Highland Estates Section 2

Southbury, Connecticut

King's Mark Environmental Review Team Report

June 2004

REDUCED SCALE SUBDIVISION MAP 4
Highland Estates Section 2
 BUCKS HILL ROAD & STRONGTOWN ROAD
 SOUTHBURY, CT
 SCALE: 1"=600' FEBRUARY 20, 2004

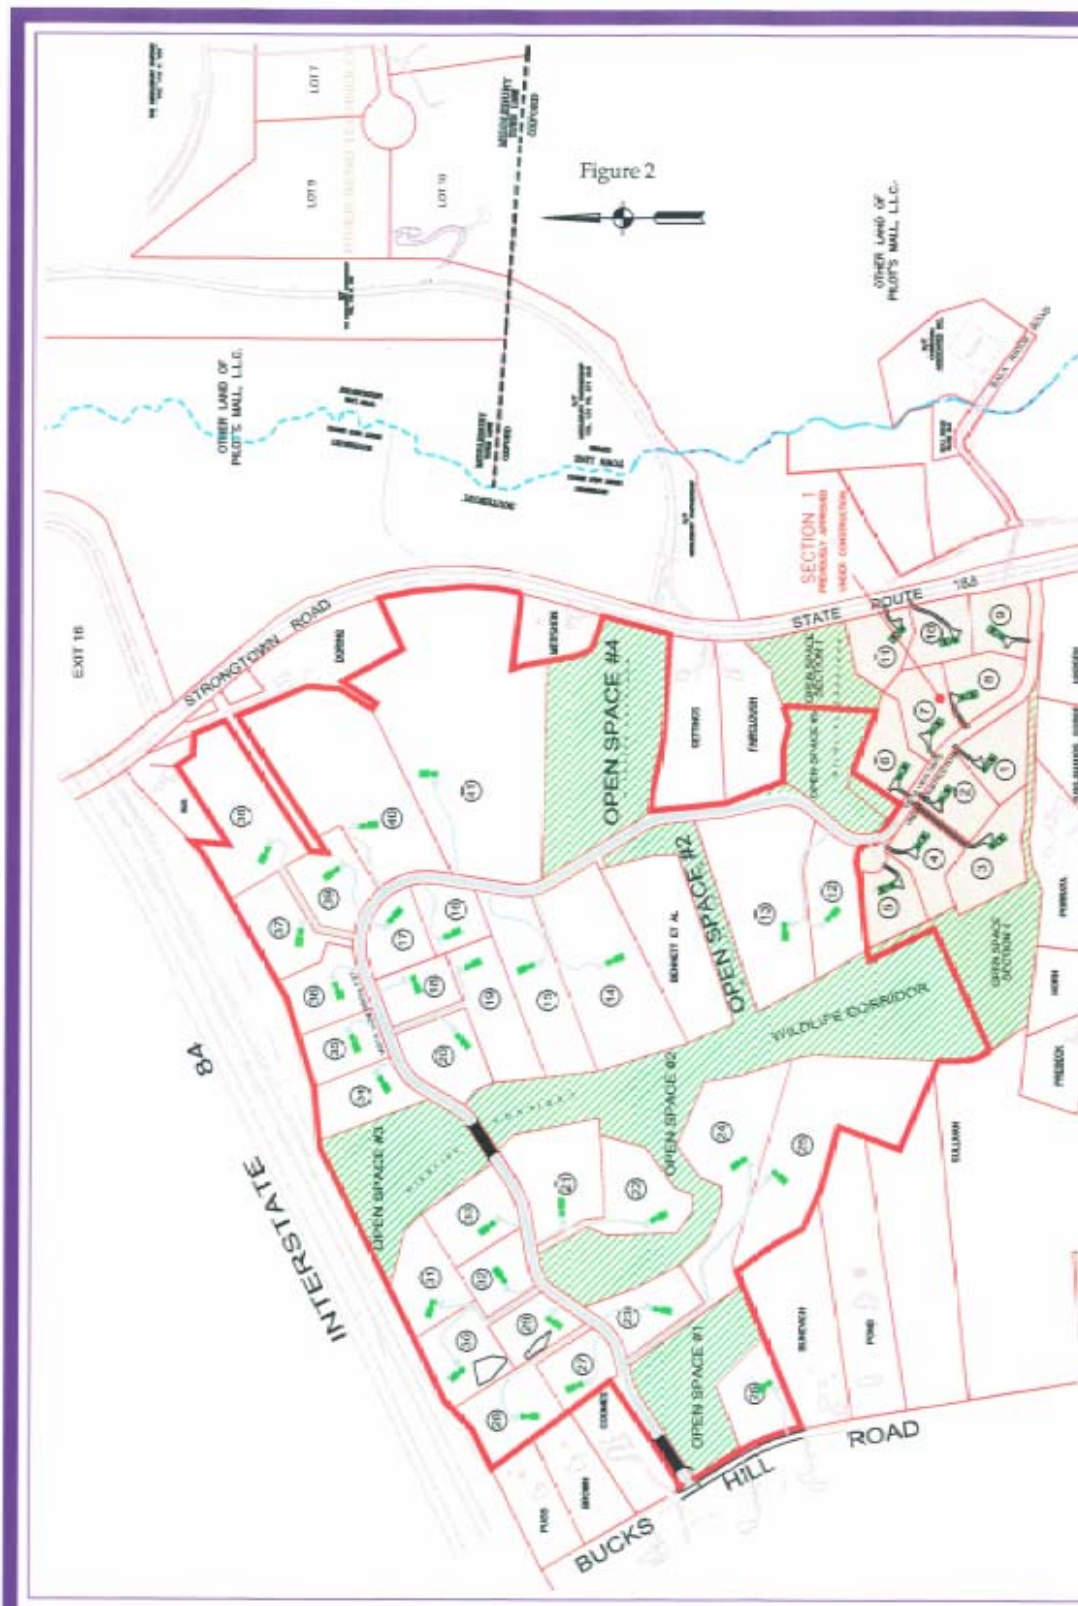
Crossing the upper wetlands on site with bridge spans will go a long way toward minimizing impacts to what appears to be valuable functioning wetlands. First discussed is the bridge that spans the wetland connecting Open Space Parcel #2 and #3. The road sloping down to the wetland from the east has an adequate detention basin (Detention Basin # 3), paired with a plunge pool, filter berm and bio-filter. These structures will greatly improve the water quality of the road runoff entering the wetland. However, storm water runoff from the road sloping in from the west does not have the same measures to renovate the quality of water entering the wetland. It is understood that the west-side storm sewer outlet services half the road length that the east site does. However, there is an opportunity to divert some of the road runoff into a sediment control structure and then it could be allowed to feed the wetlands on lot #21. Accomplishing this would minimize the pressure on the energy dissipater located on the east end of the bridge and keep an intermittent supply of water to the wetland to keep it viable. If this is accomplished the energy dissipater at the east end of the bridge will be adequate to handle the runoff from the short stretch of road between the wetland on lot #21 and the bridge (including the bridge span).

The following lot numbers have wetland and wetland setback areas within 80 feet of the proposed house Lot #22, 23, 24, 26, 31 and 34. The reason these lots are identified is to inform the wetland commission that the new homeowners will most likely want to create lawns, sheds, pools and extra yard space, horse barns

Lot #14 has a 200 foot long section of driveway that will be cut into the topography. An additional 300 feet of driveway will be feeding stormwater down to the driveway cut from above. However there is no stormwater transport measure for the entire driveway. During construction, this cut will collect and concentrate stormwater flow and shoot water and suspended sediments out onto the Vista View Drive Extension. There should be a stormwater control measure designed along the driveway corridor with an associated energy dissipater at the outlet, or possibly it could be tied into the Detention Basin #2 network. Some of the stormwater that collects on the upper portion of the driveway could be channeled into the reverse slope bench associated with road cut bank. To a lesser degree lot #41 is a similar situation.

This reviewer believes the stormwater treatment train proposed for Detention Basins #1, #2 and #3 will be very effective at renovating the quality of stormwater runoff. If this has not been accomplished already please consider having the applicant illustrate a typical detail of a detention basins with proposed

- Lot 32 has a proposed leaching system that is located 45 feet up gradient of a possible foundation drain for the dwelling. A minimum of a 50 foot

- The design calculations for the lot 15 system contains a typographical error where the system spread provided is 88 L.F. and not 80 L.F.
- The length of individual leaching rows must not exceed 75 feet measured from the inlet in systems without intermittent dosing. This should be addressed in the final design plans for the proposed leaching systems on lots 17, 18, and 19.

Figure 5
Future Land Use

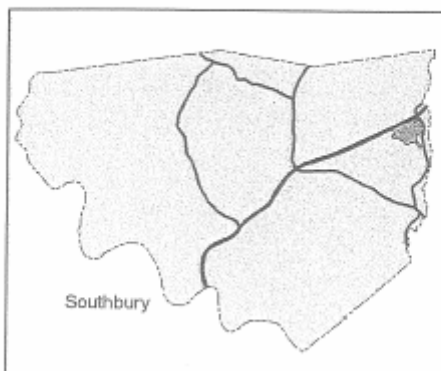
Based on the Future Land Use map (Figure 5) the proposed development site is recommended for conservation as a Rural Area. The Regional Plan states that any development in a Rural Area should respect natural resource and environmental constraints and preserve the rural character of the area. Intensity of development should be determined by the availability of infrastructure and other appropriate support services. The Highland Estates development site also contains several areas indicated as having severe environmental constraints according to the Future Land Use map. The proposal includes these areas within the five open space areas proposed for the site.

Figure 6
Natural Resource Constraints

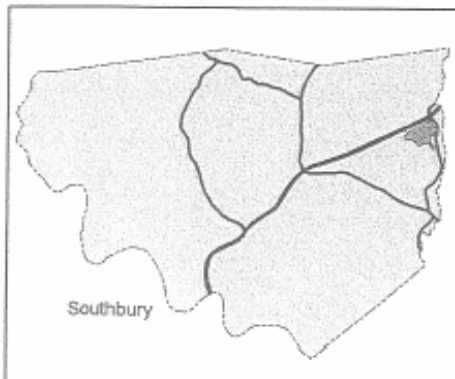
The Regional Plan lists four natural resource constraint classifications. Classification is based on the soil composition, slope, presence of wetlands and floodplains, and the presence of significant other natural resources. Based on guidelines listed in Table 2, approximately 14% of the proposed site contains land classified as having natural resource constraints prohibitive to development, 40% is severely constrained, 45% is moderately constrained, and less than 1% is minimally constrained. The majority of areas with prohibitive and severe natural resource constraints are contained within the proposed open space areas. The thirty lots contain primarily moderately constrained land (Figure 6). The

proposed Vista View Drive extension will pass through two areas classified as having prohibitive natural resource constraints. The road will have to cross a large area, located at the Bucks Hill Road entrance, classified as having a prohibitive natural resource constraint. The brook at proposed Open Space Area #3 is within a much smaller area with a prohibitive constraint, and can be more easily crossed with little disturbance.

On-site water supply wells and sewage disposal systems are proposed for the Highland Estates development. The Regional Plan recommends a maximum density of 0.5 units per acre for severely constrained areas and 0.7 units per acre for moderately constrained areas. This would equate to lot sizes of 2.0 and 1.5 acres, respectively. The proposed lot #26, which has direct access from Bucks Hill Road, may not be consistent with the guidelines for natural resource constraints listed in the Regional Plan. The lot contains prohibitive and severely constrained land and a further review of this lot is recommended.
